<b>Delegated Report</b>		<b>Analysis sheet</b>		<b>Expiry Date:</b>	03/10/2024
		n/a		<b>Consultation Expiry Date:</b>	15/09/2024
<b>Officer</b>			<b>Application Numbers</b>		
Tony Young			1. 2024/3311/P 2. 2024/3450/A		
<b>Application Address</b>			<b>Drawing Numbers</b>		
Land adjacent to 85 Clerkenwell Road London EC1R 5AR			Refer to draft decision notice		
<b>PO 3/4</b>	<b>Area Team Signature</b>	<b>C&amp;UD</b>	<b>Authorised Officer Signature</b>		
<b>Proposals</b>

1. <u>Planning application</u> - Installation of a Pulse Smart Hub with integrated digital screens and emergency functionality including provision of defibrillators. 2. <u>Advertisement consent application</u> - Display of illuminated content on digital screens integrated within new communication Hub.					
<b>Recommendations</b>		1. Refuse Planning Permission 2. Refuse Advertisement Consent			
<b>Application Types</b>		1. Full Planning Permission 2. Advertisement Consent

The application site comprises an area of public footway adjacent to No. 85 Clerkenwell Road, on the south side of Clerkenwell Road, between its junctions with Leather Lane to the west and Hatton Garden to the east. The site is situated near to a

*Images 1 & 2 – proposed communications hub with integrated display screens*

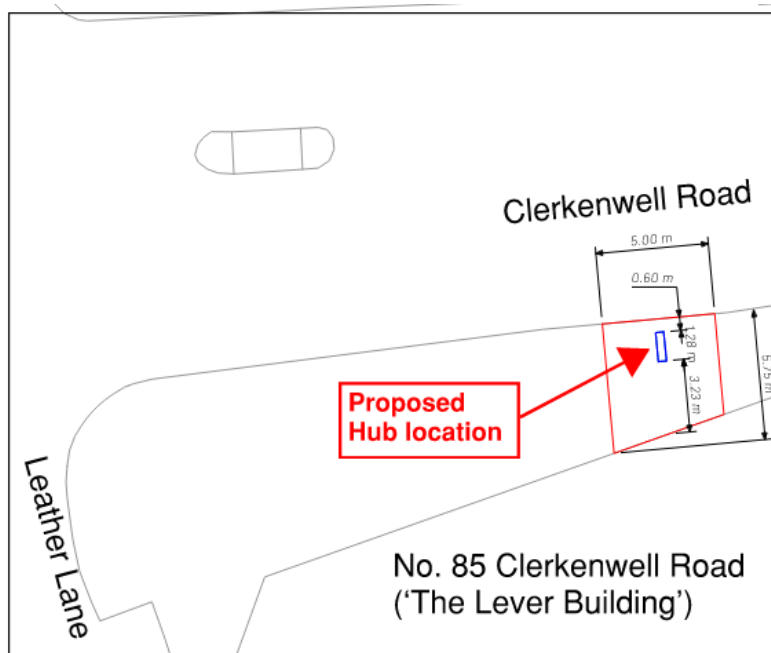
- 3.11 The proposed hub structure is considered to be poor in design terms and appears to have been primarily designed around the inclusion of two large digital screens on each of the main elevations. It would seem from the images of the proposed hub included within the application submission (see Images 1 and 2 above) that the size of the hub unit itself has been determined by the dimensions of the advertising panels. As such, the two illuminated digital advertising display screens occupy the majority of area available on each elevation of the structure (facing west and east respectively).

- 3.13 However, this has not been the case and the design approach has resulted in the creation of a large monolithic structure which gives the overall appearance as a large free-standing, advertisement panel rather than a structure for any other purpose.

*Images 5 & 6 – showing proximity of site to The Lever Building (positive contributor within Conservation Area) and Bourne Estate (Grade II listed buildings)*

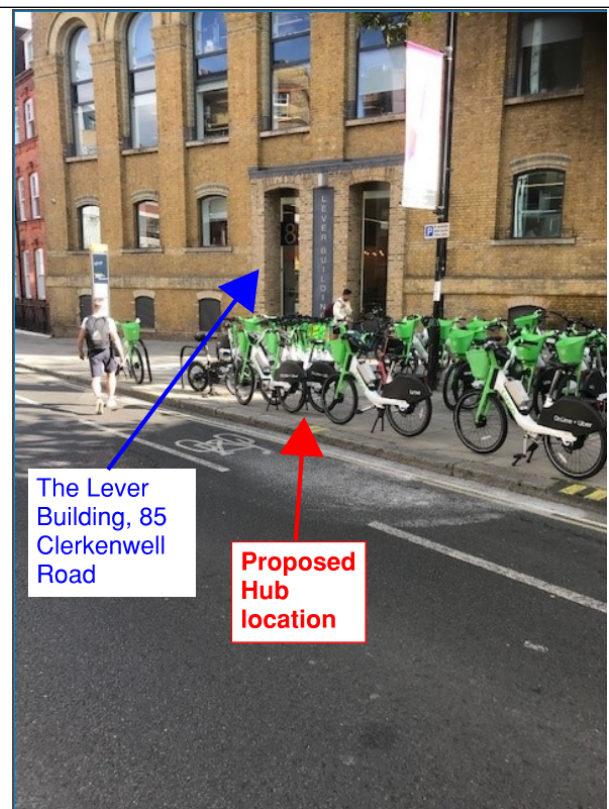
- 3.9 No. 85 Clerkenwell Road ('The Lever Building') which comprises a 6-storey building was once part of the Griffin Brewery and introduces the industrial heritage of the Area. Accordingly, the building is identified in the Hatton Garden Conservation Area Appraisal and Management Strategy Statement (adopted September 2007) as making a positive contribution to the Conservation Area (see Images 5 and 6 below).

- 3.10 The Grade II listed buildings, (south side) Bourne Estate (northern part), Nos. 87-101 Leather Lane, are located east of the application site, near the junction with Leather Lane (see Image 6 above). The application site is also noted as being situated within a key view area (View 4: Clerkenwell Road looking west toward Lever Building) as identified in the Hatton Garden Conservation Area Appraisal and Management Strategy Statement by virtue of the view's significance within the Conservation Area due to the interesting and rich townscape character that is framed within this view.

Image 7 – comparison of different communication kiosks/hubs (proposed hub structure in red)

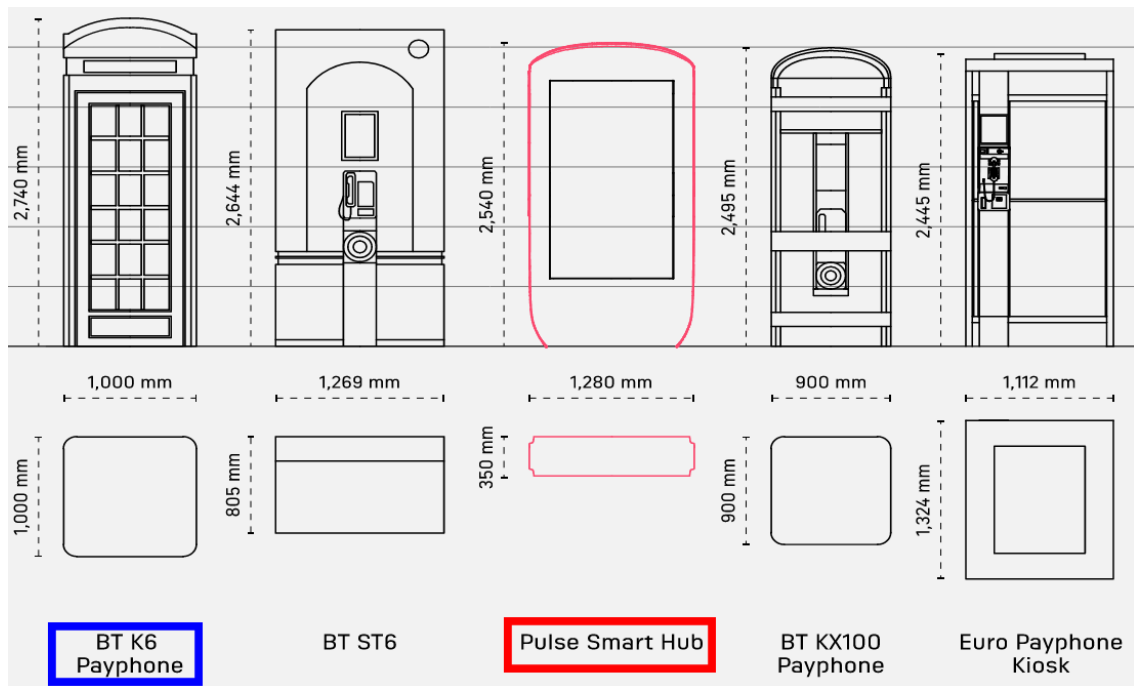
- 3.14 The dark grey anodised metal, black and clear laminated glass with textured fiberglass would have a shiny finish and incongruous contemporary appearance within the streetscene. While the applicant's planning statement describes the design of the proposed hub as referencing a traditional red phone box, it is the Council's view that the proposed structure bears little relation. Indeed, a comparison of both a traditional red phone box and the current proposal as shown in

the application submission not only shows a lack of similarity in design of them both, but also a substantially larger profile (see Image 7 below).

- 3.19 Whilst the proposed hub structure is shown in Image 7 above as having a smaller footprint than, say, a traditional red telephone box, this is primarily through a difference in depth rather than in width. Any difference therefore is not something that would be experienced by a pedestrian as the large width and profile of the proposed structure would be most noticeable and prominent to the pedestrian on approach, restricting their views and visual amenity in this context. Additionally, it is emphasised that there is no kiosk or hub of any kind in situ in this location, and therefore, the applicant's comparison of footprint dimensions with a traditional telephone box (or

*Image 8 – showing existing street furniture and features at the application site*

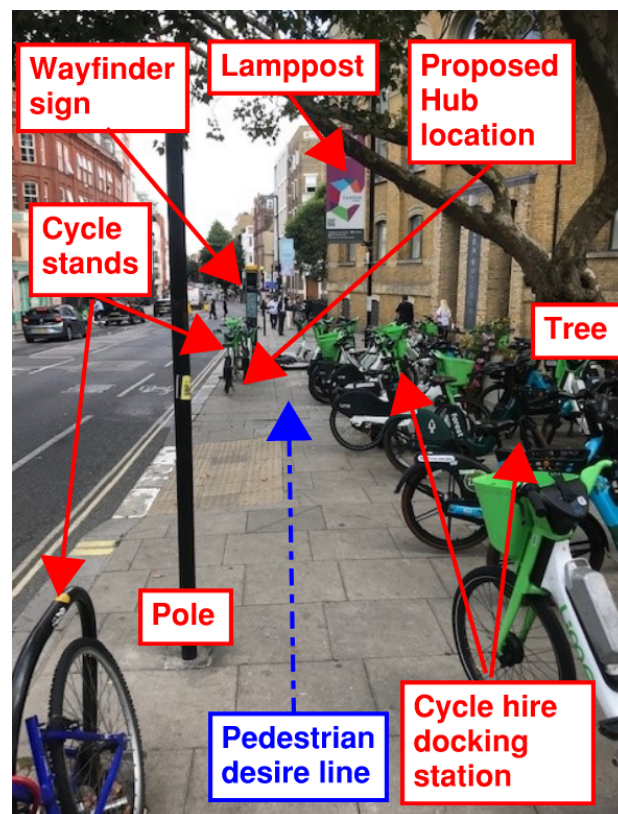
- 3.58 Following a site visit by the planning case officer, it is clear that the proposed hub structure would be located directly in the pedestrian desire line at the kerbside, and add cumulative visual and physical clutter in the streetscene given the degree and layout of existing street furniture. This would result in a significant physical and visual obstruction to pedestrians and could lead to dangerous situations involving pedestrians walking on the adjacent cycle track in the road adjacent to the proposed site. This is a particular concern for blind and partially sighted pedestrians and those with mobility issues (see Image 8 below).

- 3.59 Additionally, given that all user facilities associated with the proposed hub (such as, free Wi-Fi and phone, wayfinding / mapping services, local information provision, 999 emergency service and safety buttons, etc.) are provided at the side of the structure which faces onto the public highway, any members of public using the facilities will have to stand in an area beyond any existing furniture zone, so further reducing the amount of pavement space available for pedestrians to move comfortably along the public highway and pass by. This is an important and notable difference between the previous application for a telephone kiosk in 2017 and the current proposals as the user in that previous case would be able to stand inside the kiosk when accessing the facilities.

Images 9 & 10 – showing proximity of application site to pedestrian crossing on Clerkenwell Road (looking south-west and north-east respectively)

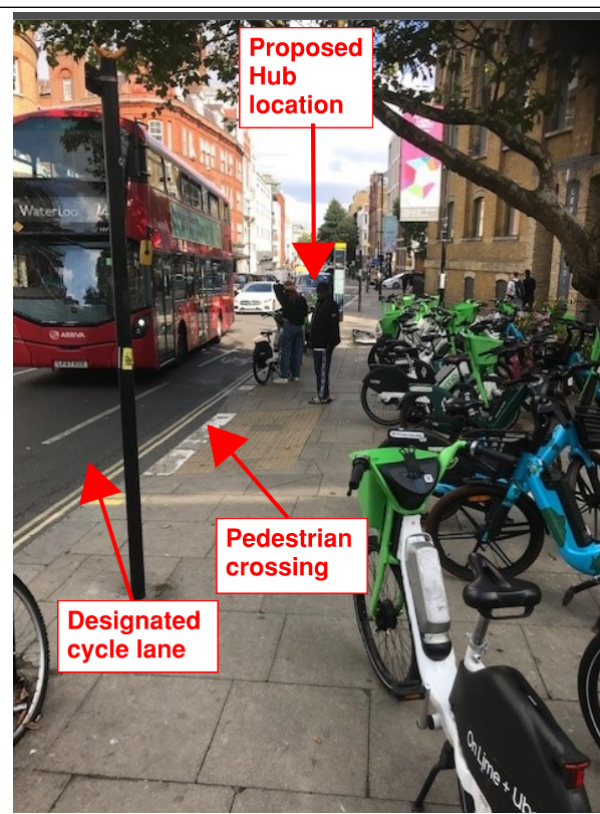
- 3.65 Images 9 and 10 below show the approximate position of the proposed hub location in context with the surrounding streetscene. The proposed hub structure (with integrated digital advertising screens on both sides) would be installed within approximately 15m of a busy pedestrian crossing located to the north-west of the hub's proposed position, contrary to the above Transport for London guidance.

Image 11 – showing proximity of proposed hub structure (blue) to a pedestrian crossing in Clerkenwell Road

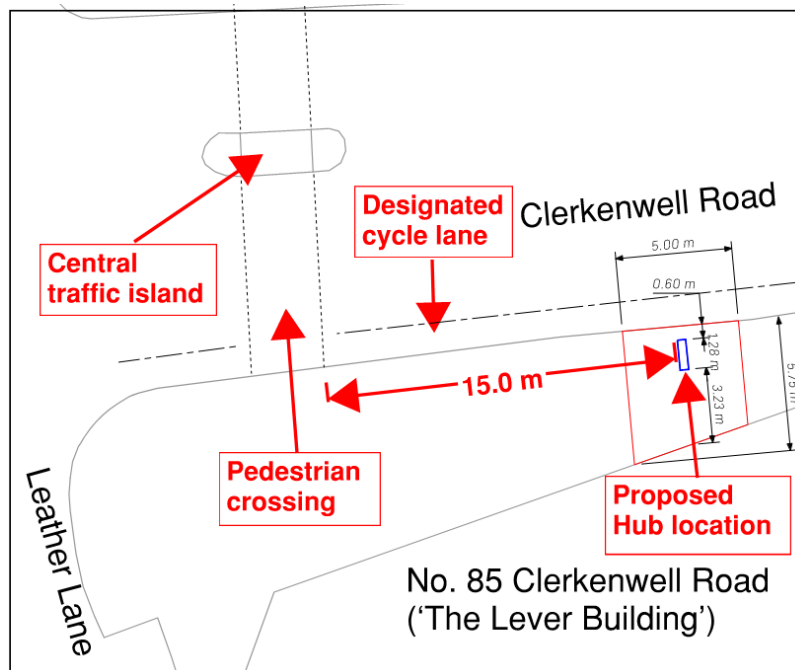
3.66 This degree of proximity is also shown in Image 11 below which has been scaled and measured from the applicant's submitted drawings pack.

3.67 The proposals would introduce a significant distraction to pedestrians attempting to use the crossing when looking in a north-easterly direction towards the proposed hub structure and oncoming road traffic, given the close proximity of both in relation to each other, as a result of the structure's size, location, illuminated displays and orientation.
